Technical Bulletin / Safety Alert

Unique ID No: TBS2012-TBSA-01

Subject: Driftrunner & Brumby Master Cylinders – Incident Notification

Applicable to: Design Registered Transport Braking Systems MDR083991TBS,
MDR083991TBS-1 & MDR096013TBS

Figure 1: Master Cylinder Assembly GA. Item 3 is the piston cup seal.

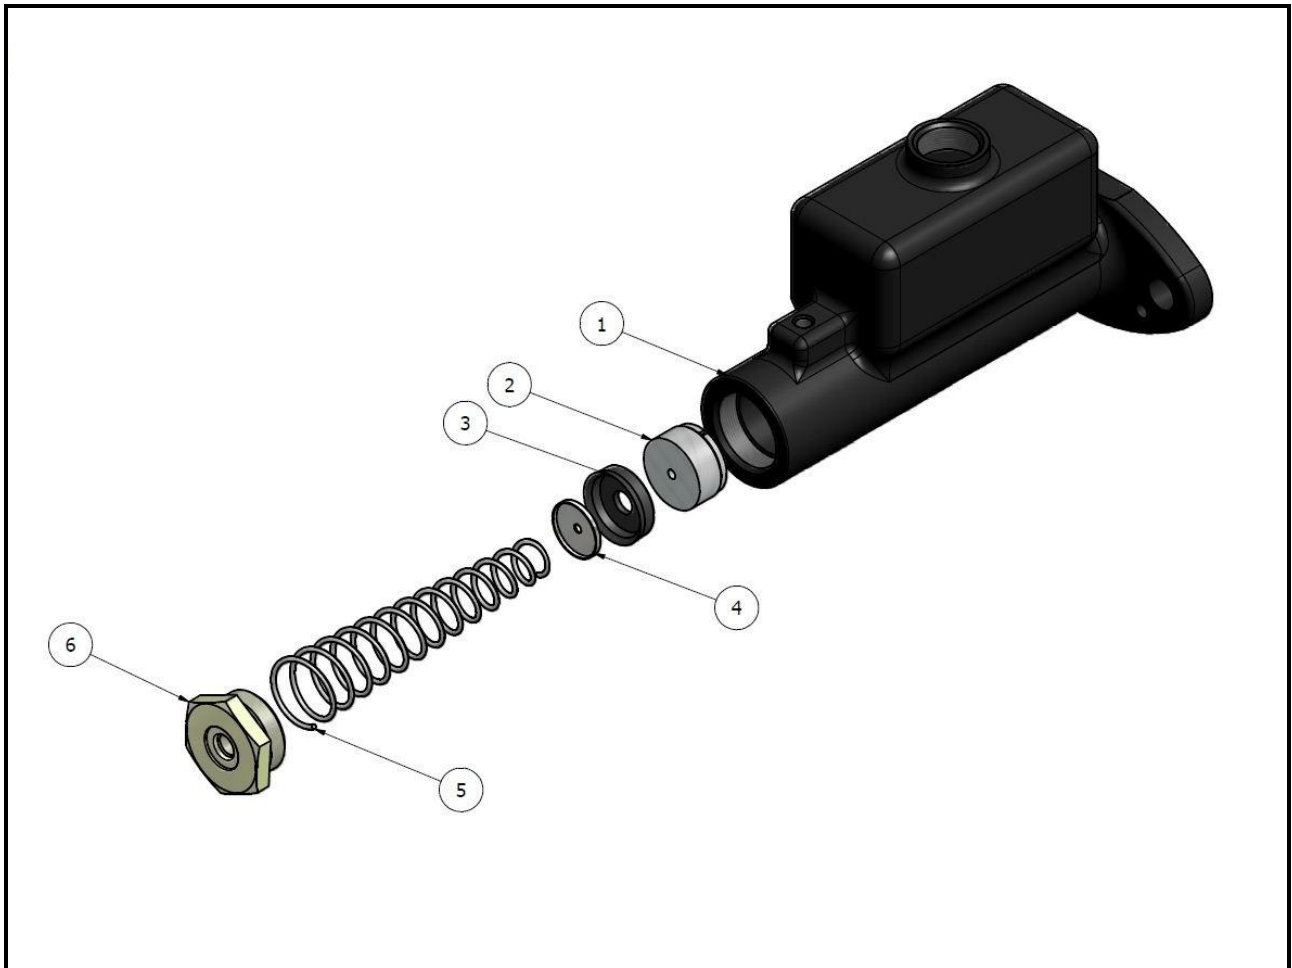
Initial investigations identified bypassing in the master cylinder and the supplier confirmed that a batch of piston cup seals (refer item no. 3 in Figure 1 below) did not conform to designed dimensional requirements. An interim batch of seals was produced to address non-compliant product whilst the master cylinder supplier resolved the original issue with the piston cup seal supplier. It has been reported that some of the interim batch of seals have suffered a similar bypassing issue to that of the original supply. Due to this non-conforming product the master cylinder supplier has sought piston cup seal supply from an alternative (Quality System endorsed) supplier and these new seals are now available.

The master cylinder supplier has completed performance testing of the master cylinders and resolved the piston cup seal dimensional conformance issue with all new master cylinders contain conforming product. These master cylinders can be identified by the marking “**AHYD21-1238R-M**” stamped on the housing mounting flange plate.

1. Gauge (nominally 0 – 2000psi) to be installed down-stream of the master cylinder.
2. Service Brake pressure applied and held.
3. Observe pressure gauge. Pressure (nominally 1100 – 1200psi) must not decay within approximately 30 seconds.

Any master cylinder assemblies that do not meet the above performance test requirements are to be removed from service and replaced with conforming product supplied by VLI Diesel Pty Ltd.
